Accepted
Master Drainage Plan

MASTER DRAINAGE PLAN
STREET & STORM SEWER PLANS

WOODSIDE RIDGE
SECOND PLAT

LEE'S SUMMIT, MO

SHEET
C128

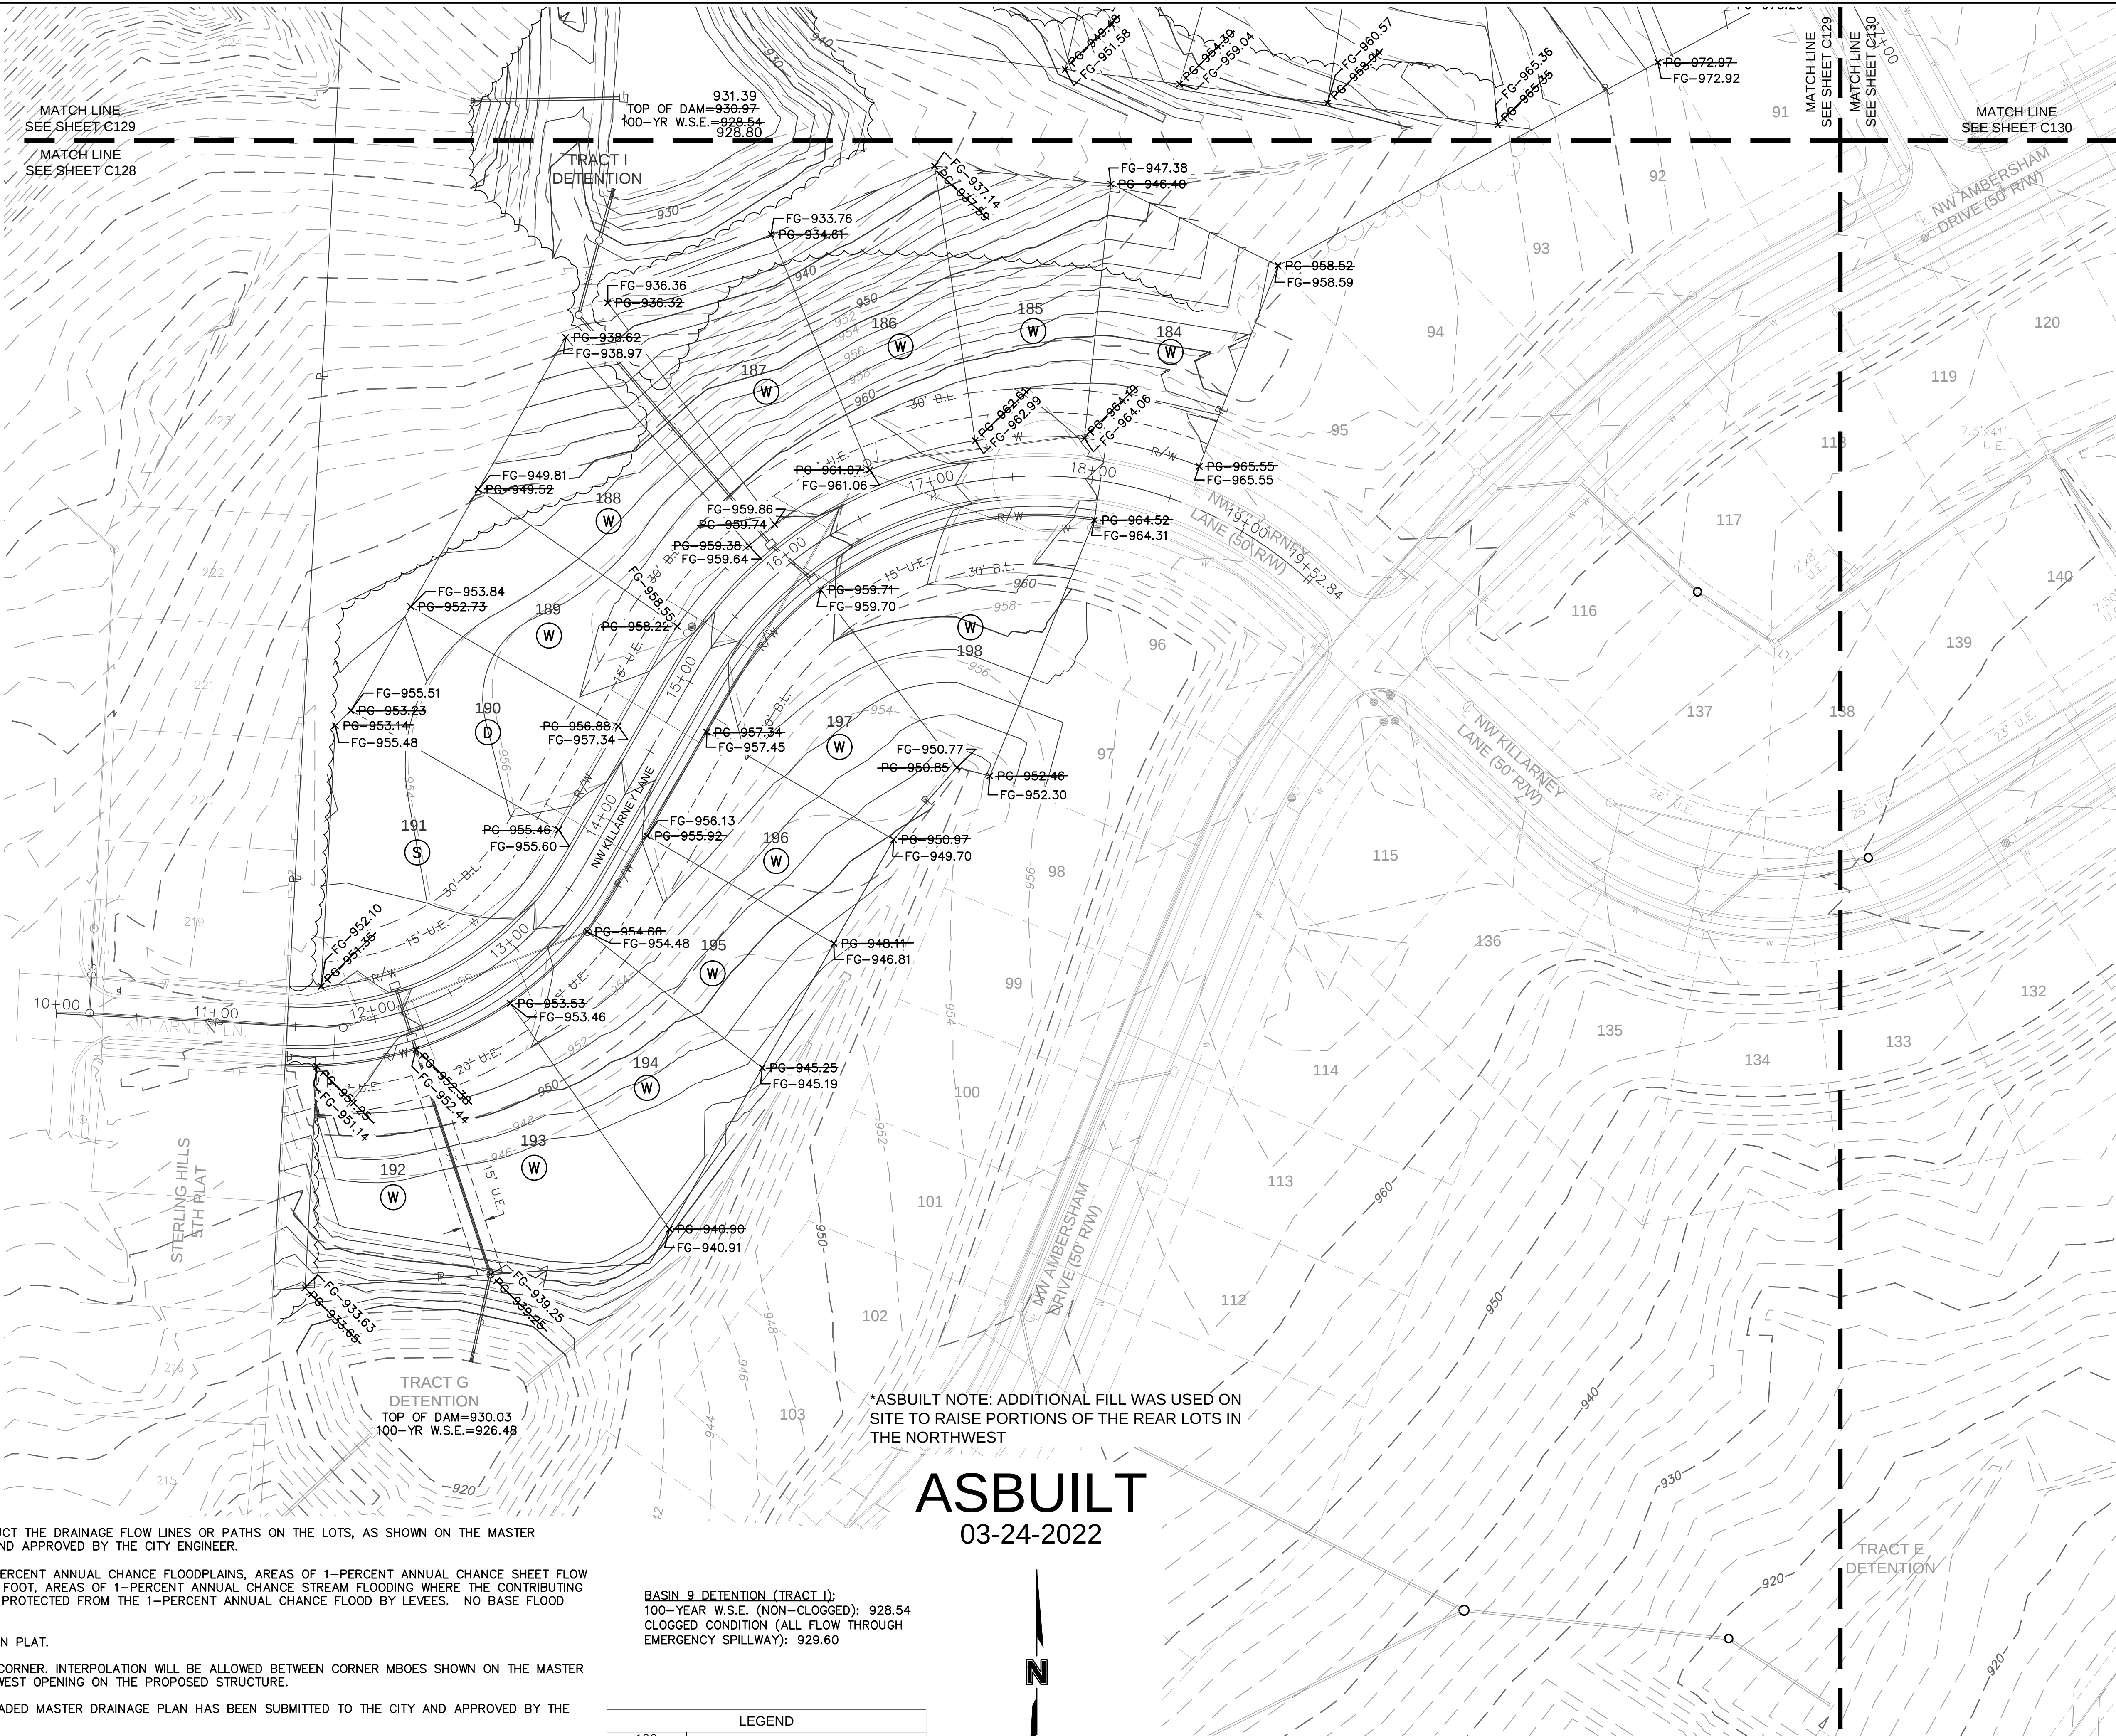
This as-graded Master Drainage Plan (MDP) has been reviewed for accuracy. It is accepted for basic conformance to the approved MDP and may be used for the review of individual lot grading (plot) plans.

SHEET
C129

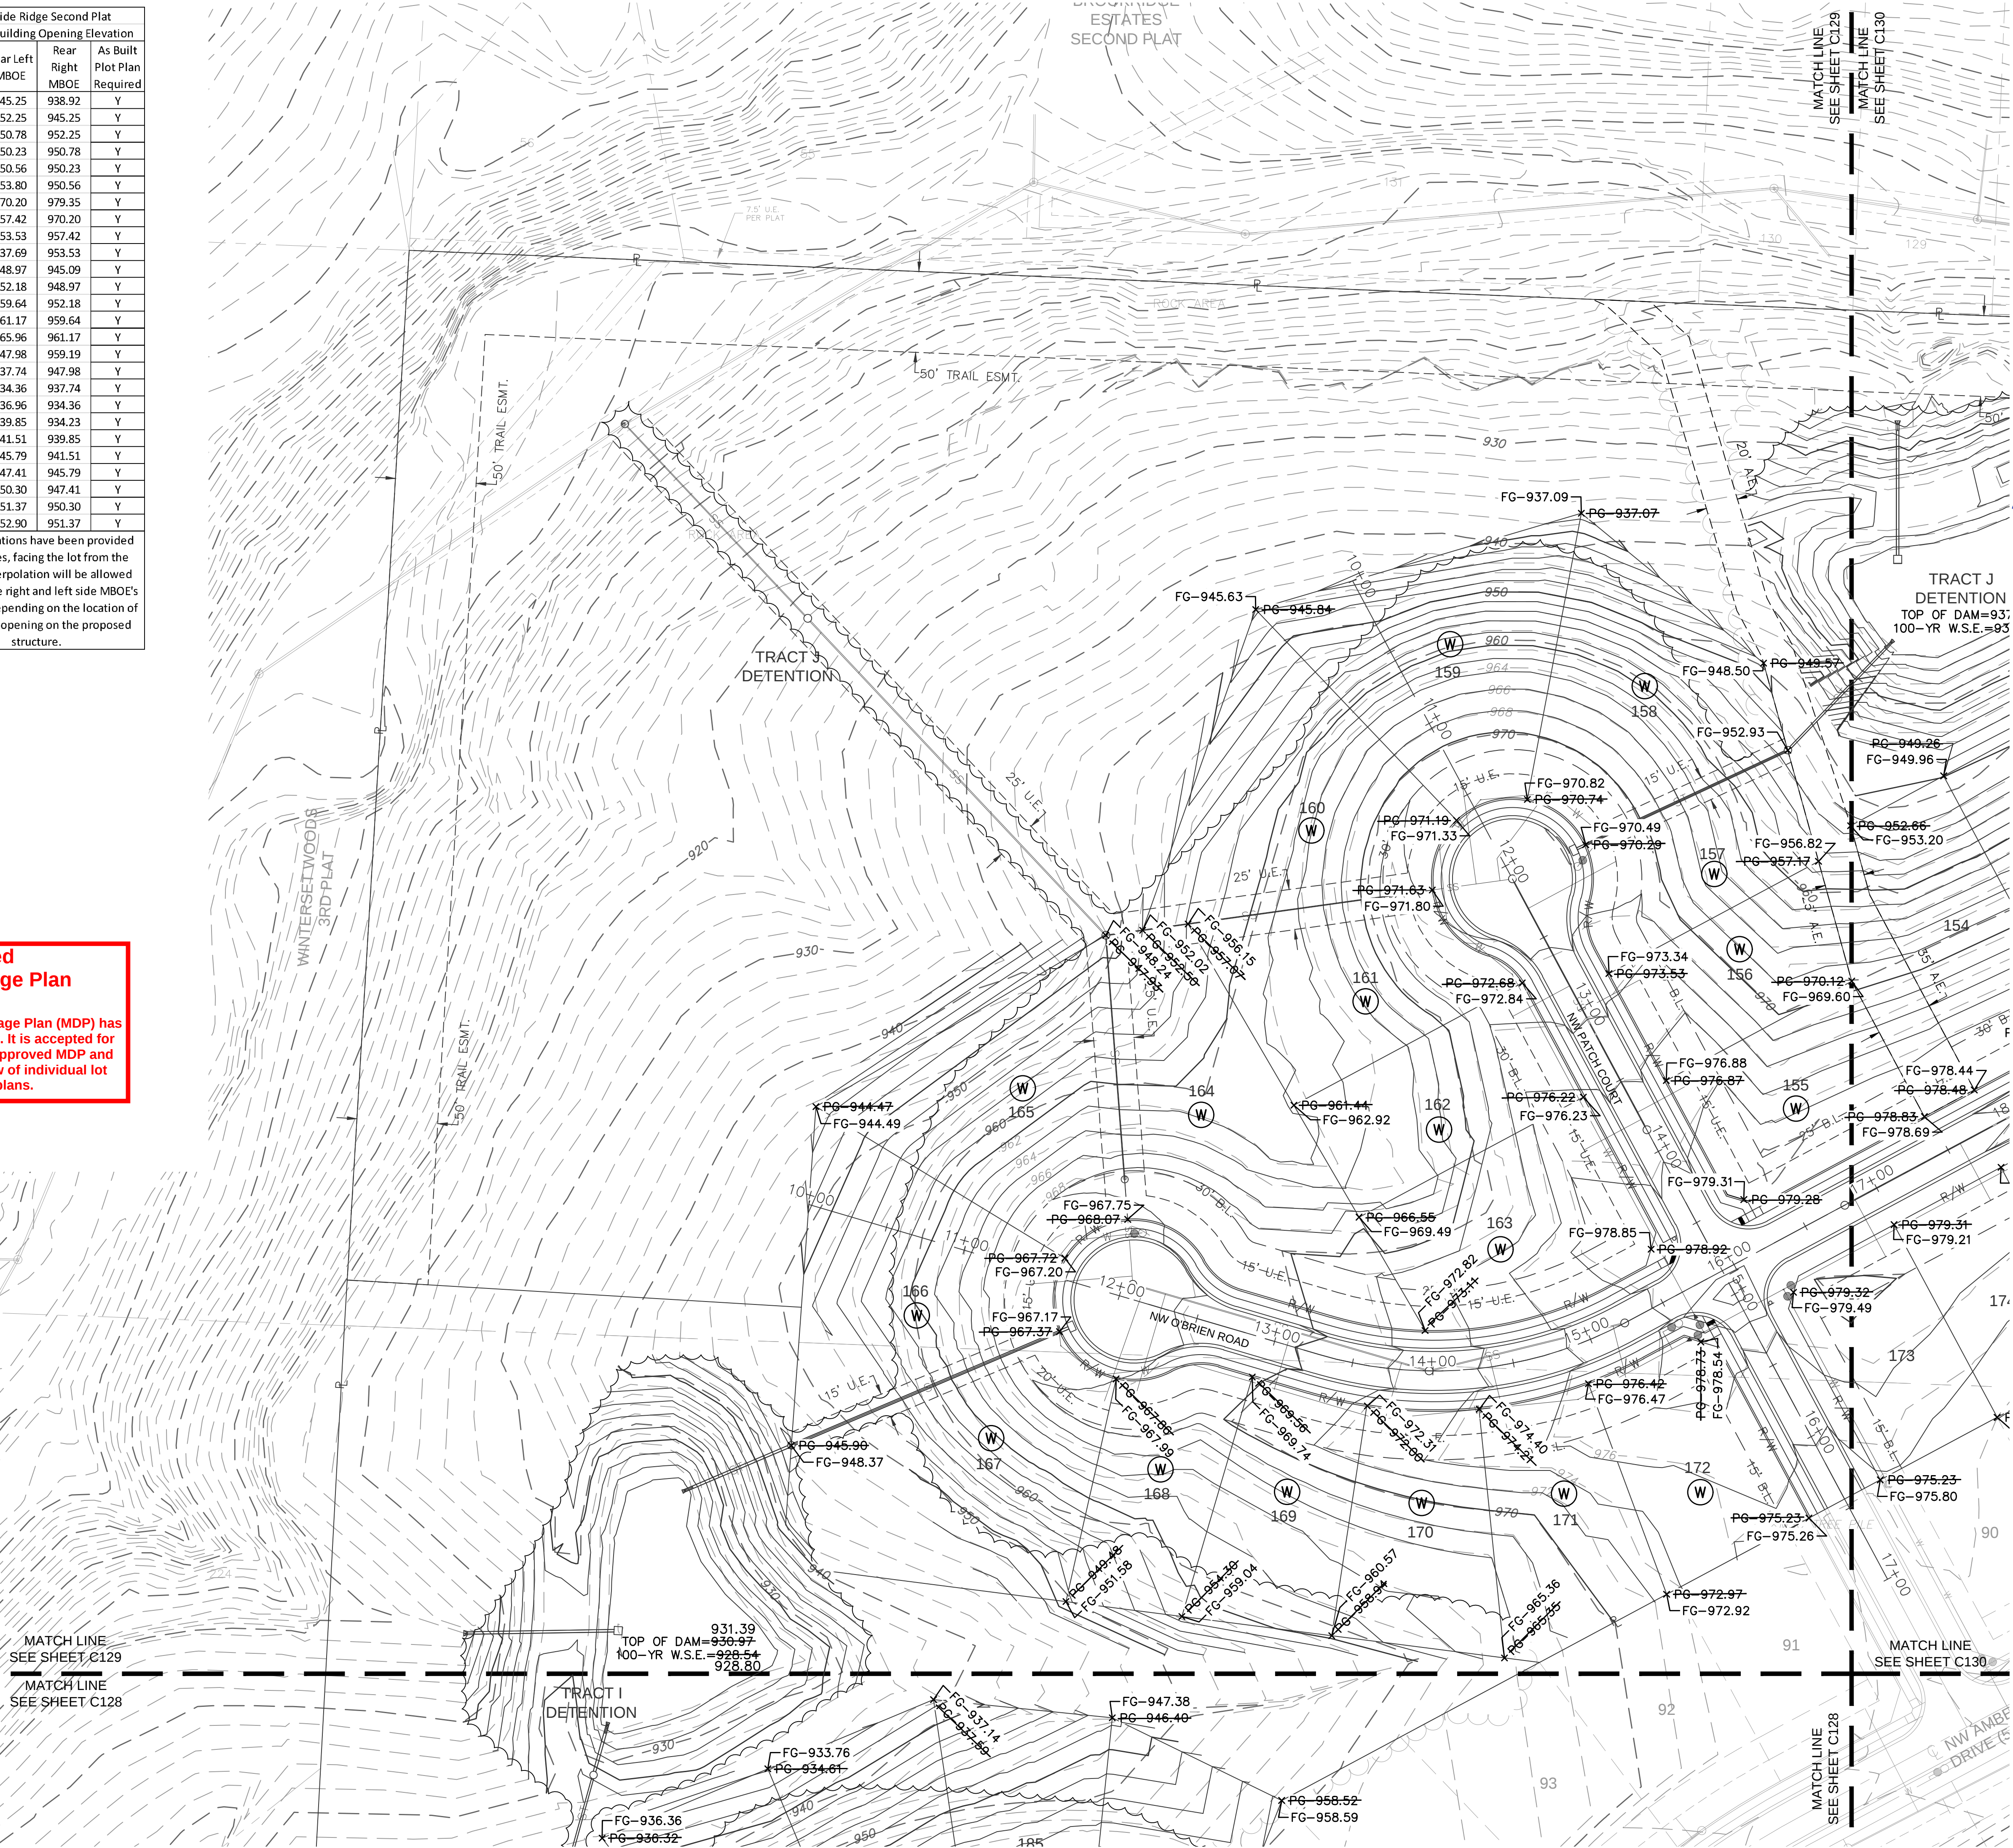
This as-graded Master Drainage Plan (MDP) has been reviewed for accuracy. It is accepted for basic conformance to the approved MDP and may be used for the review of individual lot grading (plot) plans.
